Land South and East of Aadastral Park, Ipswich

Technical Note : Response to Highways England (HE) 'Request for Information' on conference call dated 15th November 2017 (DC/17/1435/OUT)

28th November 2017

UPDATED LINK FLOW DIAGRAMS FOR THE A14 ROAD CORRIDOR (J55 to J60)

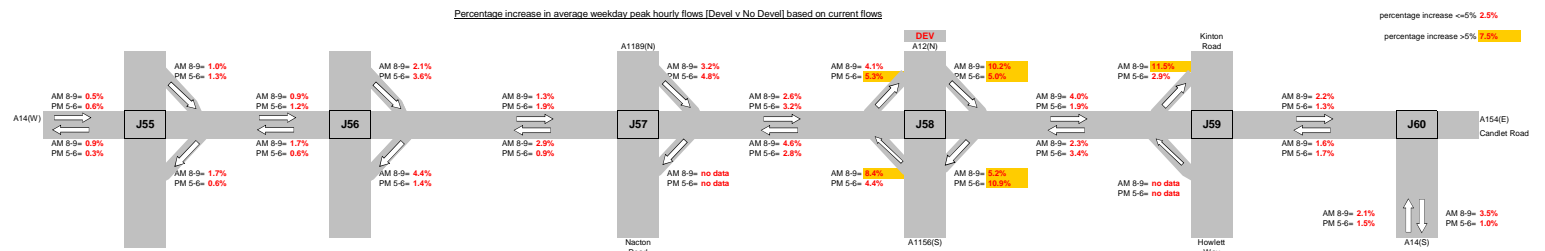
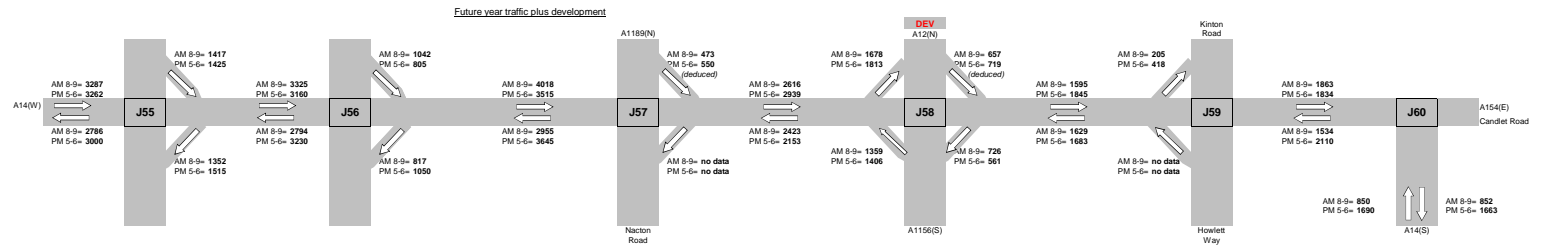
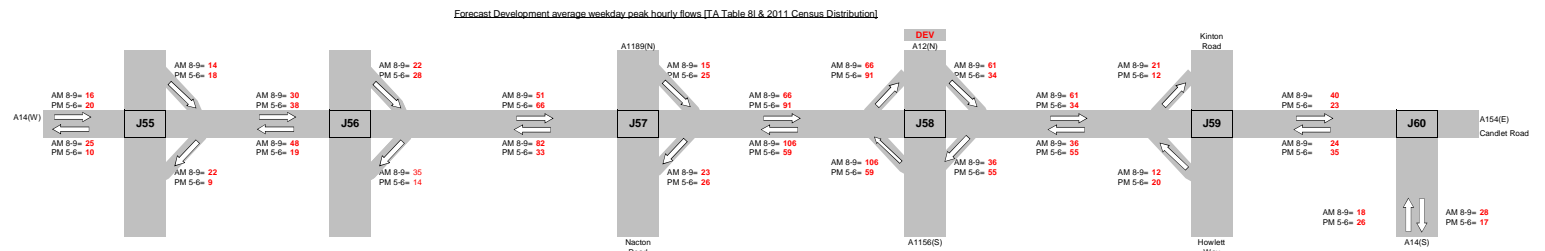
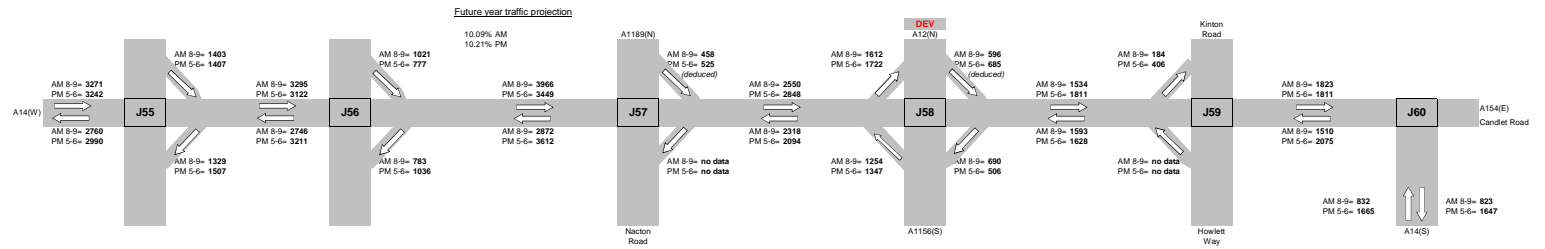
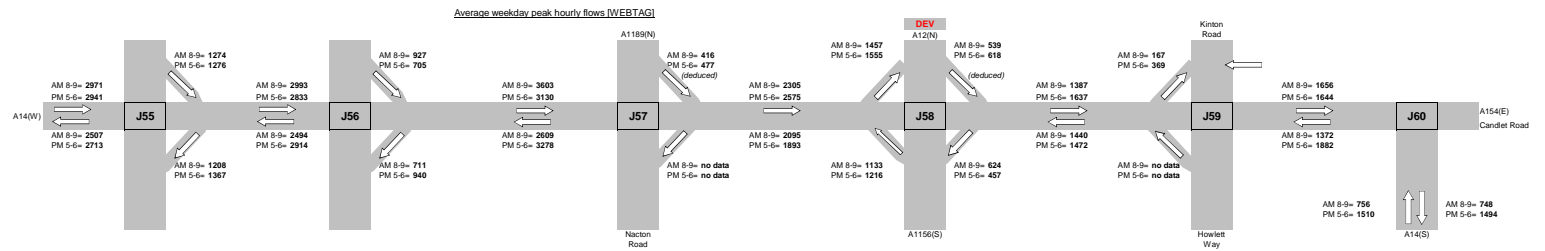
1. Updated Link Flow Diagrams for the A14 road corridor between Junctions 55 and 60.
2. Updated Merge/Diverge Assessment for the A14, Junction 58 'Seven Hills' slip roads.
3. Alternative Traffic Modelling Results for a HE defined 2027 Year Sensitivity Test.

- 1.1 The updated link flow diagrams are appended to this note. Please note that the link flows adhere to the traffic modelling scenario contained within Brookbanks Transport Assessment rev 6, though with a sensitivity test applied for 0% internalisation and 10% travel plan. For further details of this sensitivity test, please refer to Brookbanks Technical Note 44.
